# Final Report of the Plutonium Disposition Red Team

**Date: 13 August 2015**

**Thom Mason, Chair**

**Figure 2. Impact of Arbitrary \$100M and \$200M Reductions in Ops Costs on MOX Program Life Cycle Costs**

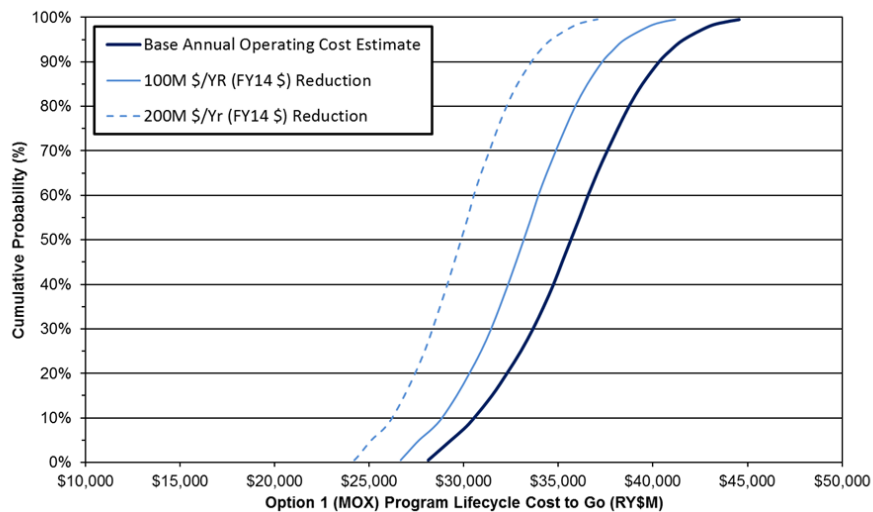
A similar impact was noted from the inflation of predicted operating costs. As can be seen from Figure 2, removing excess contingency from the MFFF operating cost estimates to bring them into better alignment with the MOX Services original estimate (~\$330M/yr, FY14 dollars) and benchmarks at the reference plant (MELOX ~\$250M/yr, FY14 dollars) and the British Sellafield MOX Plant (~\$200M/yr, FY14 dollars) reduces the overall LCC estimate for the MOX option between \$2B and \$10B. Correction of the overly protracted construction and commissioning durations and implementation of a less conservative escalation rate would decrease the LCC estimate for the MOX option even further. These examples highlight the problem with accurately estimating LCCs for multiple decade programs. Uncertainties in key input assumptions can significantly skew the results due to the dominance of escalation. This problem becomes particularly acute when funding constraints or limitations are imposed, especially when funding does not escalate but cost does. The Red Team concludes that the quantitative approach taken by Aerospace significantly overestimated the duration of the MOX facility to reach CD-4, thereby artificially inflating the LCC cost impacts of potential funding constraints. The net result was that conclusions regarding the viability of the MOX approach drawn by Aerospace could be mitigated by decisive Departmental action and consistent Congressional funding at a more appropriate level.
